THORNLEIGH STATION UPGRADE

Detailed Design Road Safety Audit

Report No 150337-THR-CI-RPT-00001
Date 24/05/2021
Revision Text Detailed Design Road Safety Audit

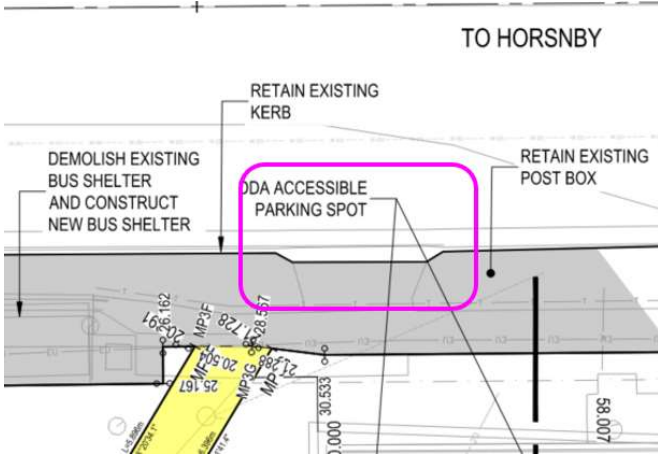
5.	<p>Concept Design Stage Audit finding, noting response 'Further design development has since identified the inclusion of a raised pedestrian crossing to be included as a variation currently awaiting formal direction to proceed'.</p> <p>Railway Parade.</p> <p>The proximity of the station exit and the desire to cross toward the footbridge and the opposite footpath may lead to vehicle hit pedestrian type incidents.</p> <p>Austrroads suggests raised pedestrian priority crossings when the number of pedestrians is higher than vehicles.</p>		High	<p>A kerb ramp has been including in the design to ensure connectivity to the Pennant Hills pedestrian overpass structure.</p> <p>A raised pedestrian crossing was considered but is however not viable without a major functional change to the area due to the existing locations of driveways, electrical poles, and the close proximity of the Pennant Hills overpass to the existing kerb line.</p> <p>Noting the existing services, a formalised crossing is raised as best way forward.</p> <p>Please note: To date based on discussions with Client, raised crossing is not considered as a part of the TAP Project.</p>
